# 802.3az D1.1 Clause 22.2.1 Transmit Deferral during LPI

Bryan Dietz  
Alcatel-Lucent  
1/6/2009

## Options for specifying

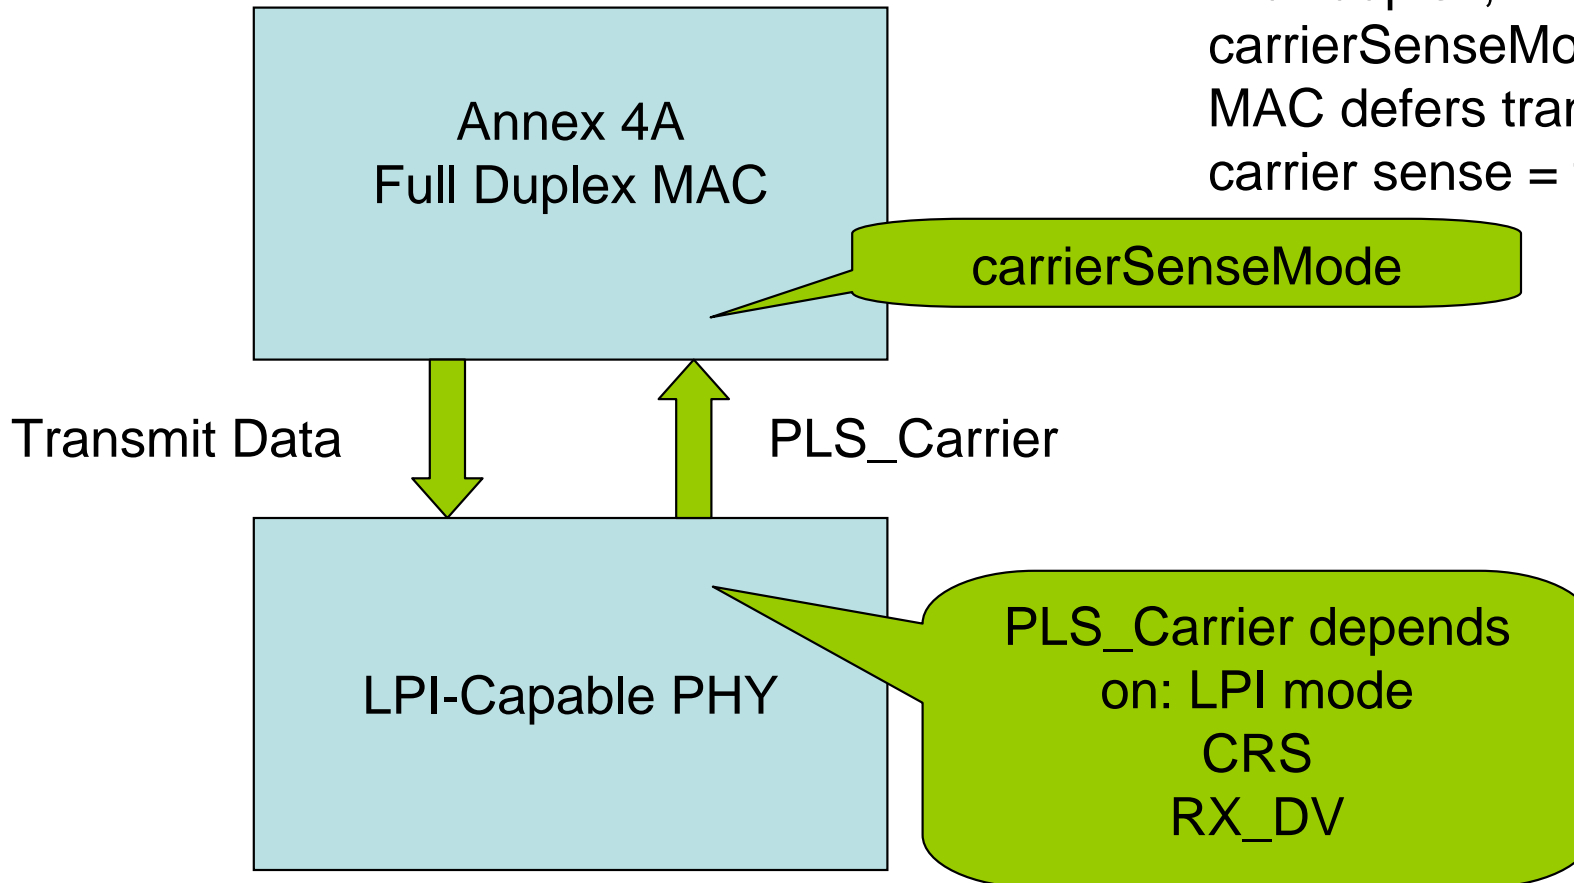
- [1] Provide set of rules for Clients
  - Require LPI Client enforce ALPI timing
  - Require MAC Client enforce MA\_DATA timing
    - Places requirements on specifications outwith 802.3
- [2] Provide a TX LPI MII State Diagram
  - State Diagram controls timing
  - Use PLS\_CARRIER.indication to enforce MA\_DATA timing
    - Only supports full-duplex mode
- [3] Provide a LPI Control sublayer
  - LPI Control State Diagram controls all timing
- [4] Close the loop
  - Don't support xMII
    - Assume pervasive access
  - Don't support physical implementation of xMII
    - Add a new signal from the PHY to the RS across the xMII
